Technical Service Information

THM 3T40 (125C) TRANSAXLE COOLER PIPE

TRANSAXLE COOLER PIPE BUZZ OR MOAN AFTER TCC ENGAGEMENT 1985-86 FIRENZA AND CALAIS MODELS

Figure 1

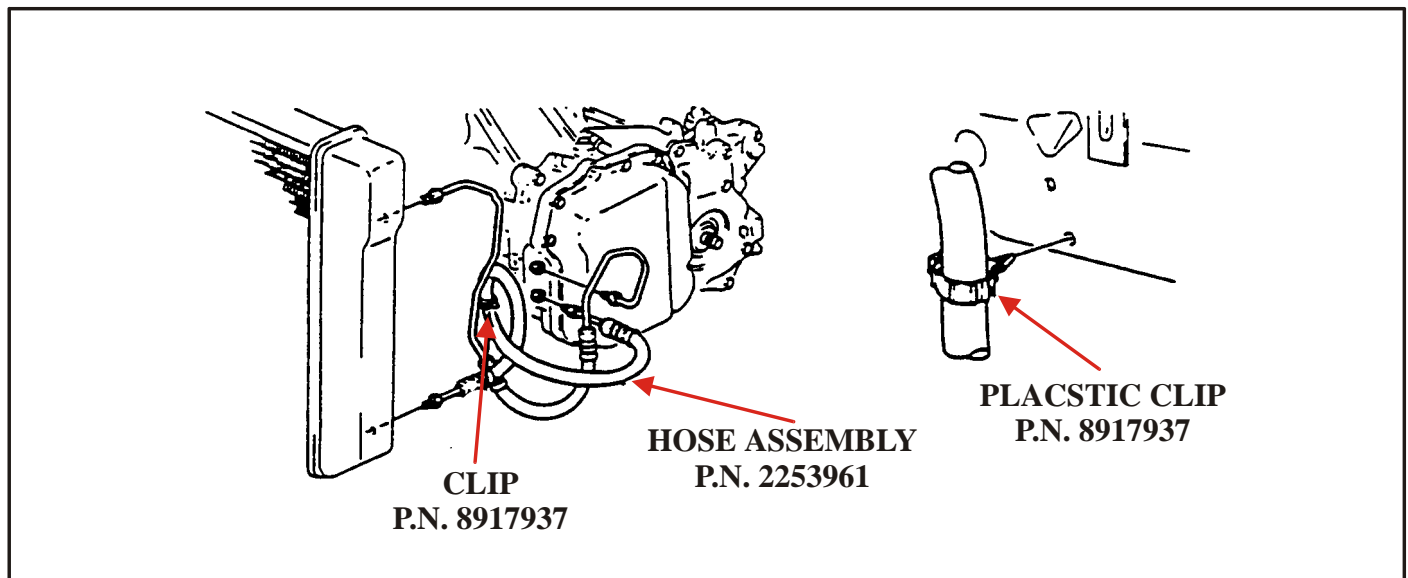
Calais only - If the noise condition is still evident, replace the lower cooler line hose assembly with a new longer hose assembly, part number 22535961. Retain hose to engine compartment side rail with clip, part number 8917937. (See figure below)
